Re: Bayer MaterialScience LLC  
125 New South Road – Hicksville, New York  
USEPA ID#: NYD002920312  
BBL Project #: 2302.32303 #5

*Demolition Work Plan*

**Bayer MaterialScience LLC  
125 New South Road  
Hicksville, New York**

**ATTACHMENT 1  
MODIFICATION TO THE DEMOLITION WORK PLAN**

FIGURE  
**1**

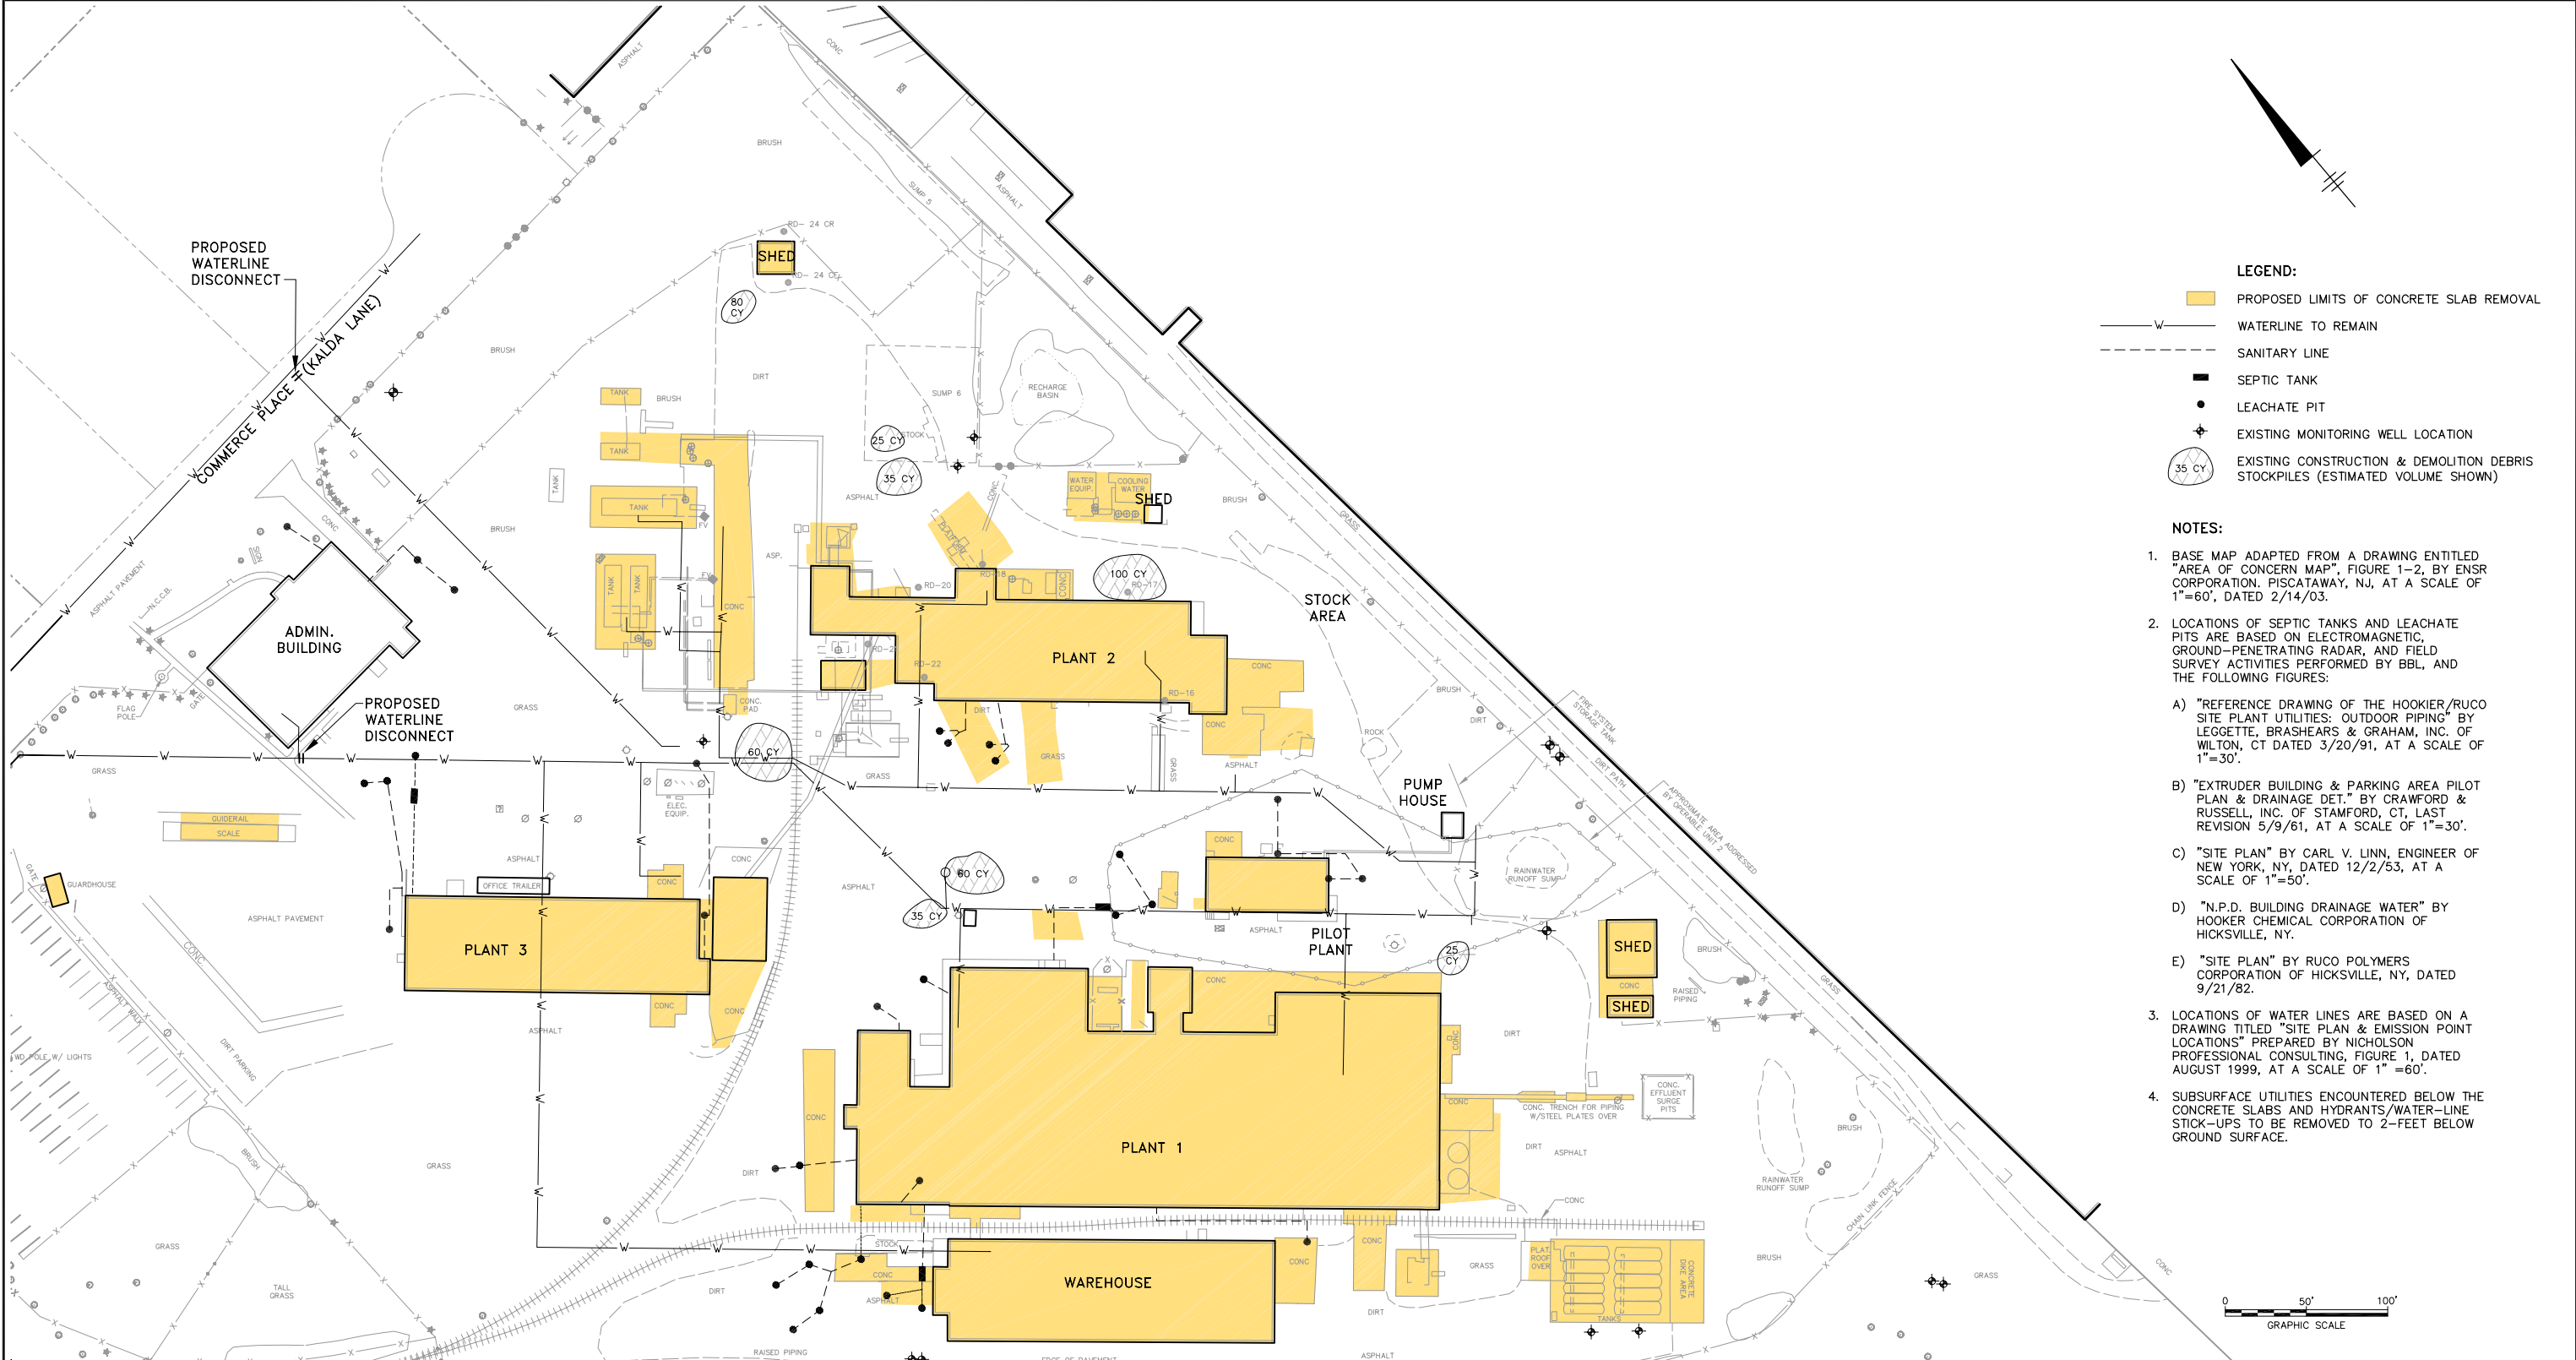
***Comment 1***

Additional discrete and composite concrete core samples will be collected to further evaluate the presence and extent of PCBs in the former building concrete floor slabs and concrete-paved areas outside the floor slabs. Under the proposed revised sampling approach, a total of 72 representative discrete samples will be collected (instead of 39 as called for in the Demolition Work Plan). The proposed discrete sampling locations will provide additional coverage across the building floor slabs, coverage in concrete-paved areas outside the slabs where no samples were previously proposed, and coverage in the general areas identified in the table in Subsection 1.3.4 where possible staining/slight staining was noticed by field sampling personnel during the RFI. Discrete samples to evaluate concrete re-use will not be collected from areas where heavy staining is observed, because concrete from such areas will be segregated during demolition for proper offsite transportation and disposal.

Under the revised sampling approach, a total of 12 composite samples will be collected, each formed from four to seven discrete samples. The revised composite sample quantity equates to one composite characterization sample per approximately 310 cubic yards (CY) of concrete anticipated to be generated by the demolition activities. Locations where discrete samples will be collected to generate composite samples are shown as red triangles on the revised version of Figure 3 (see attached PDF file). The purple lines on Figure 3 designate boundaries for each composite sample. As indicated by the purple lines, the actual area of concrete to be characterized by each composite sample is approximately the same (just over 100 feet by 100 feet). An analytical sample summary, which identifies the proposed 12 composite samples, sampling areas, and corresponding number of discrete samples to form each composite, is presented below.

As indicated above, areas of concrete flooring exhibiting heavy petroleum staining will be transported for proper offsite disposal. The approximate areas of concrete flooring exhibiting heavy petroleum staining are shown on Figure 3. Actual limits of stained concrete will be determined based on observations during a reconnaissance in support of the pre-demolition characterization sampling. Bayer had originally planned to collect discrete PCB concrete samples (uncomposed) to evaluate disposal requirements for the heavily-stained concrete. However, upon further consideration and discussion with the NYSDEC during an August 11, 2005 conference call, Bayer may instead elect to first remove the stained concrete and then collect one or more composite samples to characterize the concrete (as-generated) for disposal. Bayer will coordinate with the anticipated disposal facilities to see that the necessary analytical data is provided.
